# EVMK2HX Known Issues

## 2. EVMK2HX Rev 1.1 Known Issues

## 4. EVMK2HX Rev 2.0 Known Issues

### 2.1 EMAC Link Down Issue

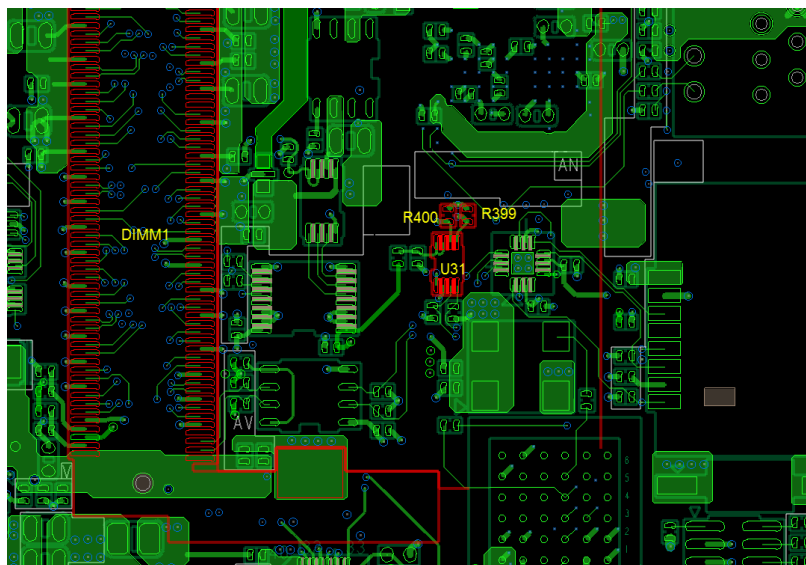
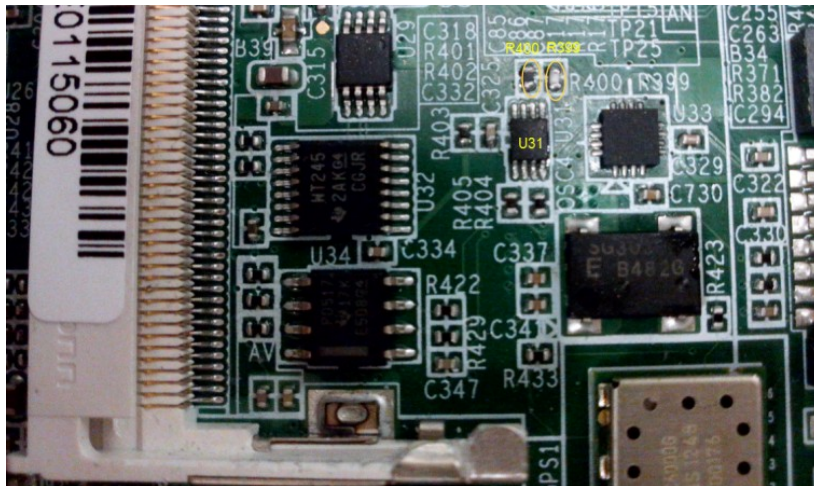
- Description: Noise on MDCLK signal impacts stability of the MDIO link. When Linux kernel sees MDIO link go down it tears down data link as well. Have not seen an issue with using MDIO link to configure external PHY.
- Workaround: Different options under investigation.
  1. Modify code not to depend upon MDIO link remaining active for EMAC communication
  2. Add stronger pull-up resistors on MDCLK and MDIO signal, by replacing R399/R400 from 4.7 kohm with 220 ohm resistors (0402 sized)

- Plans for a fix: Will clean up routing of MDCLK signal on Rev2.0. BOM will also be changed on future builds to incorporate 220ohm resistor pull-up changes.

## 2.2 VCC0V85 Voltage Drop Issue

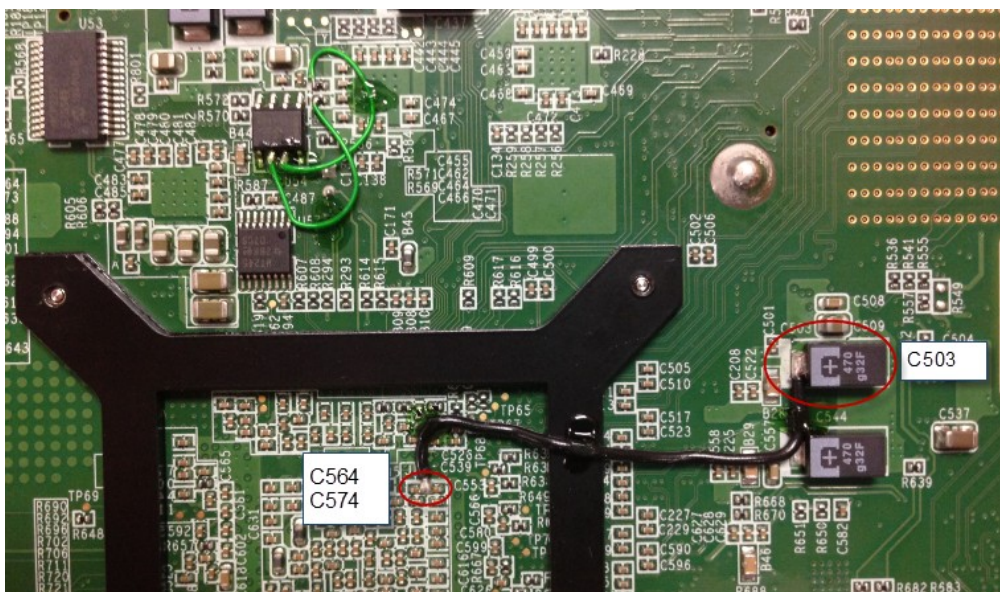
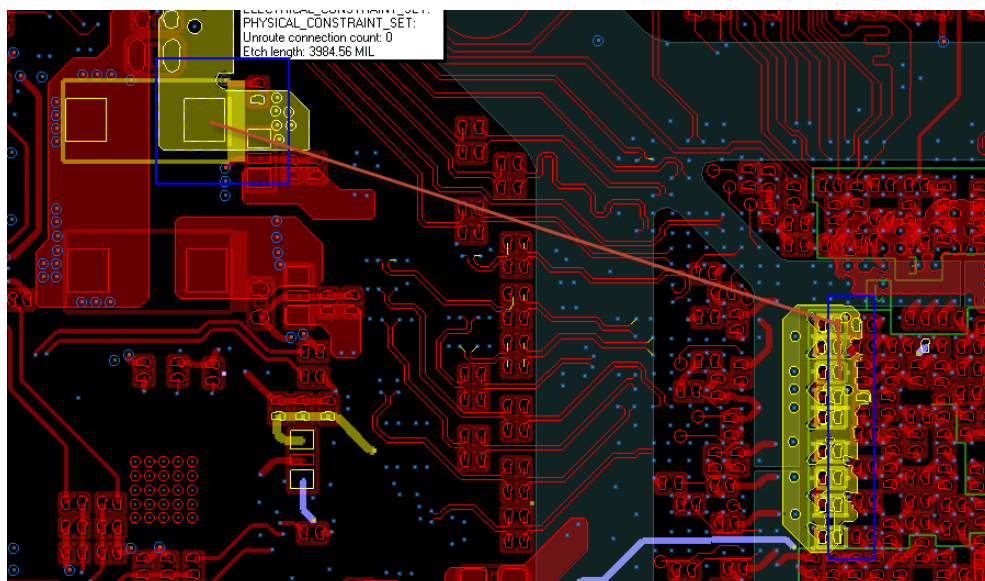
- **Description:** The trace width of the VCC085 signal is too narrow and causes a voltage drop at the pin of the SOC. Since this supply is used for SerDes interfaces it could cause SerDes interfaces to lose link. This issue has only been identified and observed on the SGMII.
- **Workaround:** A couple different options are still under investigation for their effectiveness.
  1. Add external wire to provided adequate patch for expected current from pin 1 of "C503" (net VCC0V85) to pin 1 of "C564, C574" (net VDD0V85). (Wire length = 5 cm)

Note: That the rework should not link to GND and cause short circuit.

- Plans for a fix: The trace width will be fixed on Rev2.0. The filter element on AVDDALV requires an increased current capacity (suggest up to 4A) to allow for margin on worse-case power as per latest Snowbush power estimates when all SERDES are active. Increase of current capacity on filtering elements for AVDDAHV also recommended (suggest up to 3A). Please see latest estimates below. CVDD power budgeted already on the DSP AVS supply. Both of these nets shall be implemented as copper pours up to the filters and as a plane afterwards to minimize resistance and inductance and maximize plane capacitance.

### 2.3 I2C SDA/SCL Reserve Issue

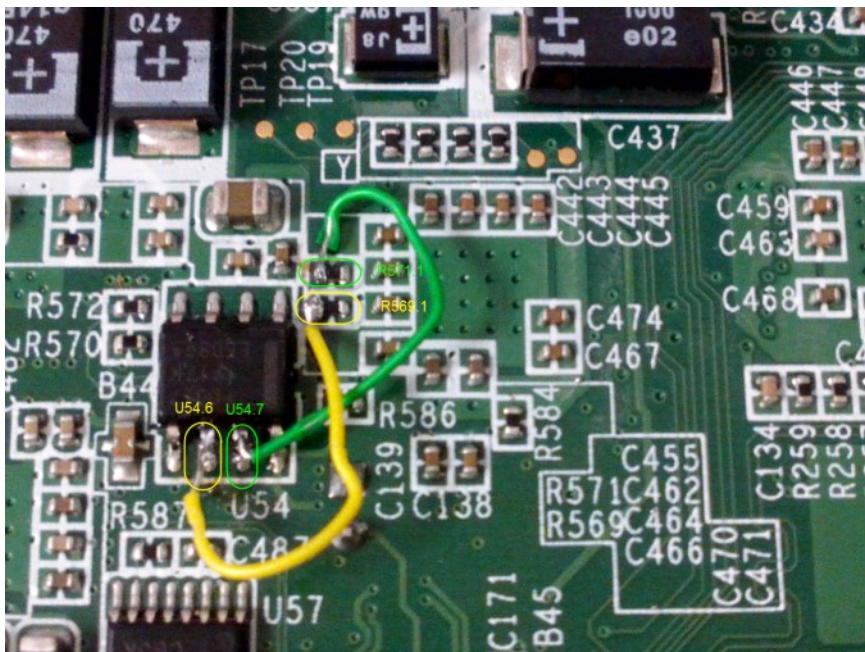
- Description: SCL and SDA are swapped on U54 bus repeater. Impacts I2C going to 120p Expansion Connector and Zone 3 RTM connector.
- Workaround: Cut the jumper wire (30AWG) to swapped signal of EXP\_SDA2\_3V3 and EXP\_SCL2\_3V3. Two wire each to similar yellow and green to link from U54.6 to R569.1 and U54.7 to R571.1 .

- Plans for a fix: This will be corrected on Rev2.0.

#### **3.2 VCC0V85 Voltage Drop Issue**

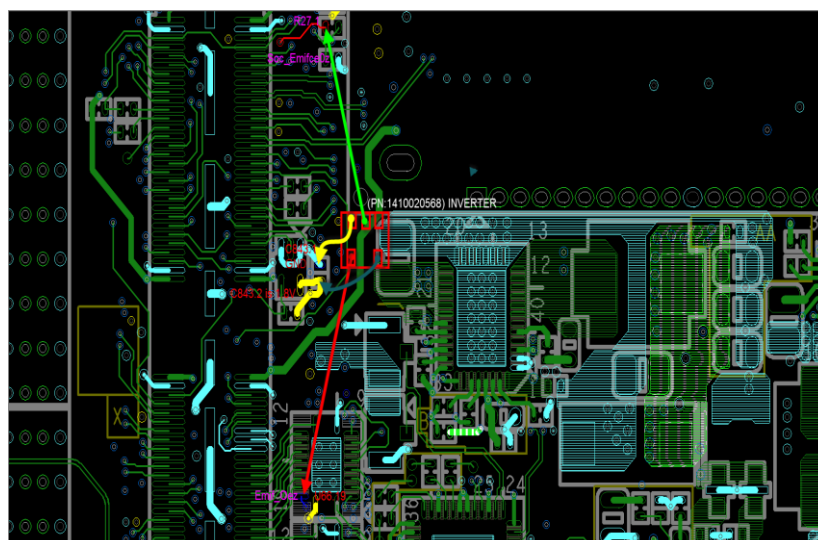
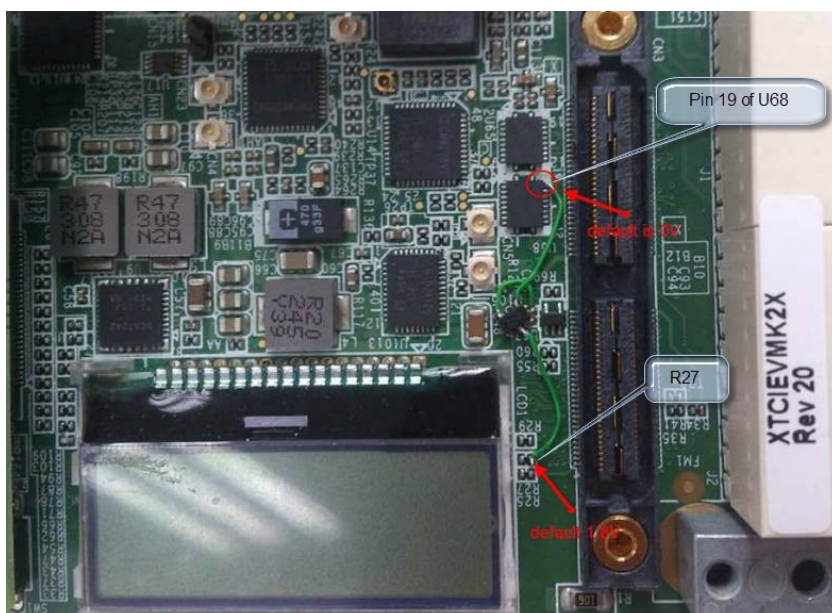
- Workaround: An external wire is added to provided adequate patch for expected current from pin 1 of "C503" (net VCC0V85) to pin 1 "C564, C574" (net VDD0V85). (Wire length = 5 cm). Also, the wire is glued on heat sink back plate for stability.

## 4.2 USB Device not work

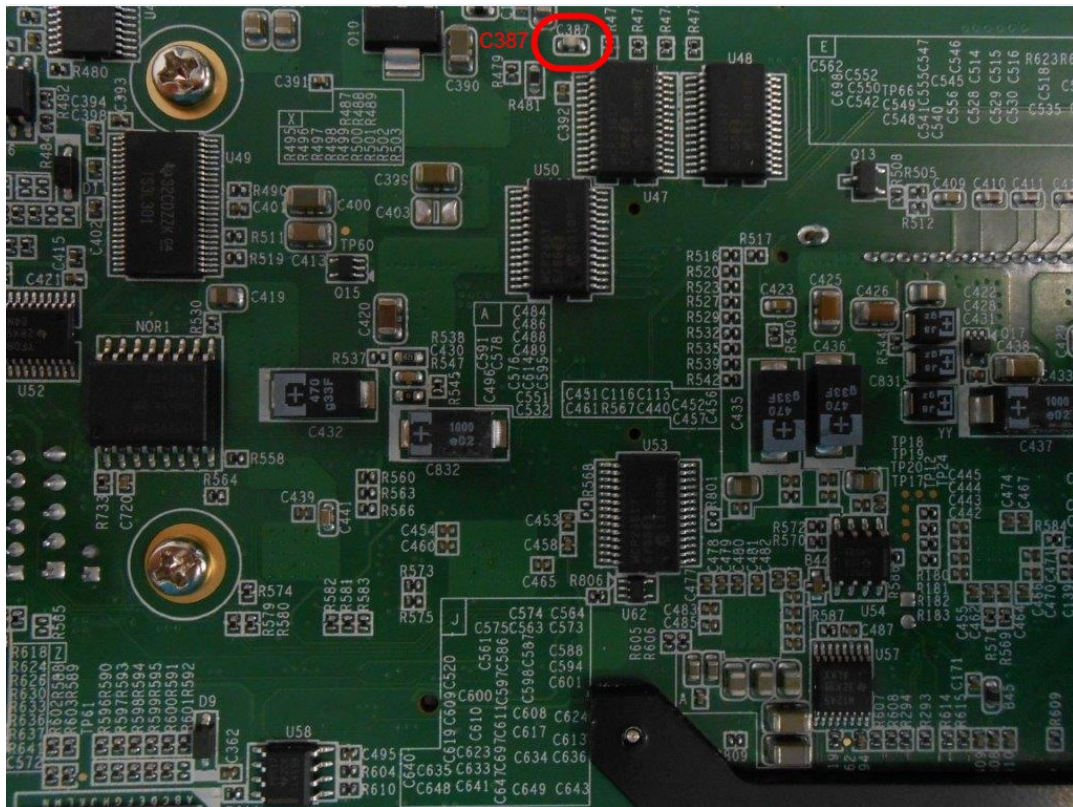
- Description: USB 3.0 port could not work even Linux kernel loaded. The cause is 5V rail turned off due to overshoot/undershoot protection.
- Workaround: A couple different options are still under investigation for their effectiveness.
  1. Increase 5V overshoot/undershoot margin in with UCD9090 XML File (UCD9090\_104\_A04.XML) in TI Fusion Power Manager Tool so 5V rail would not be turned off.
  2. Remove C387 (56pf) extra capacitor on 5V rail to solve overshoot/undershoot symptom.

- Plans for a fix: C387 will be removed in next revision EVM. User could remove C387 or apply updated xml file to solve the symptom.

### 4.3 Power up will happen SoC PWR stop

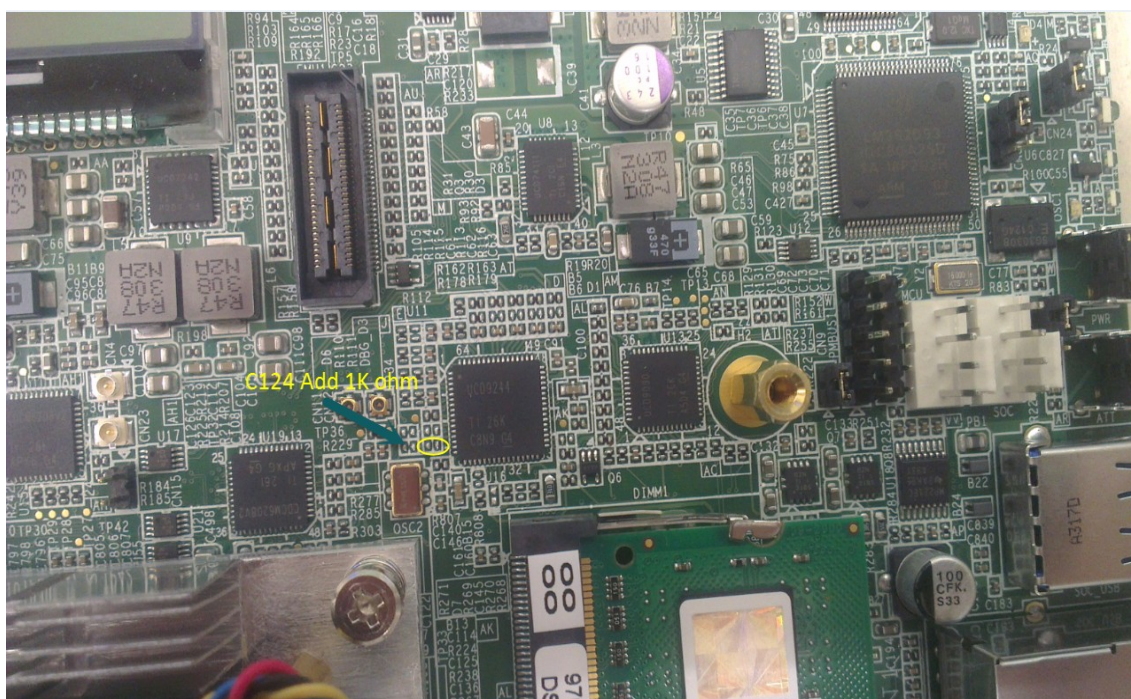
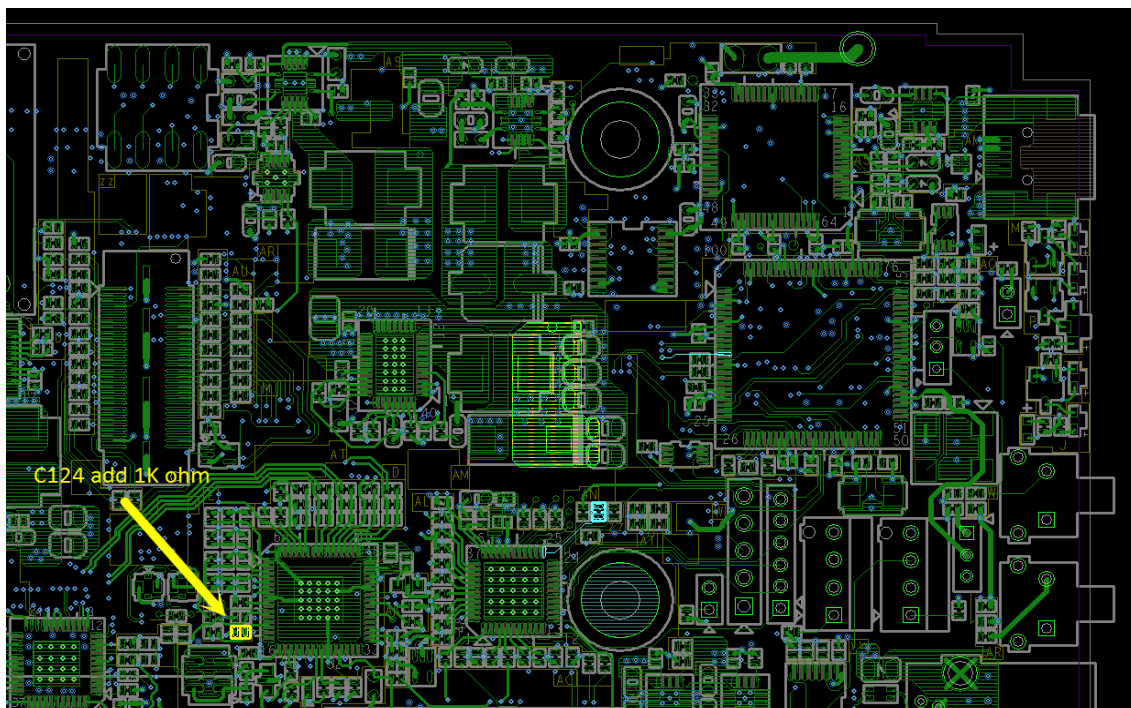
- Description: UCD controller detects a fault during power-on and aborts the power-on sequence.
- Workaround: The fault comes from un-used CVDDT rail and FLT pin is floating. Adding a 1K ohm resistor on location C124 will pull-down the un-used FLT pin and avoid false fault signal.

- Plans for a fix: The 1Kohm resistor is added before Rev 2.0 EVM shipping.
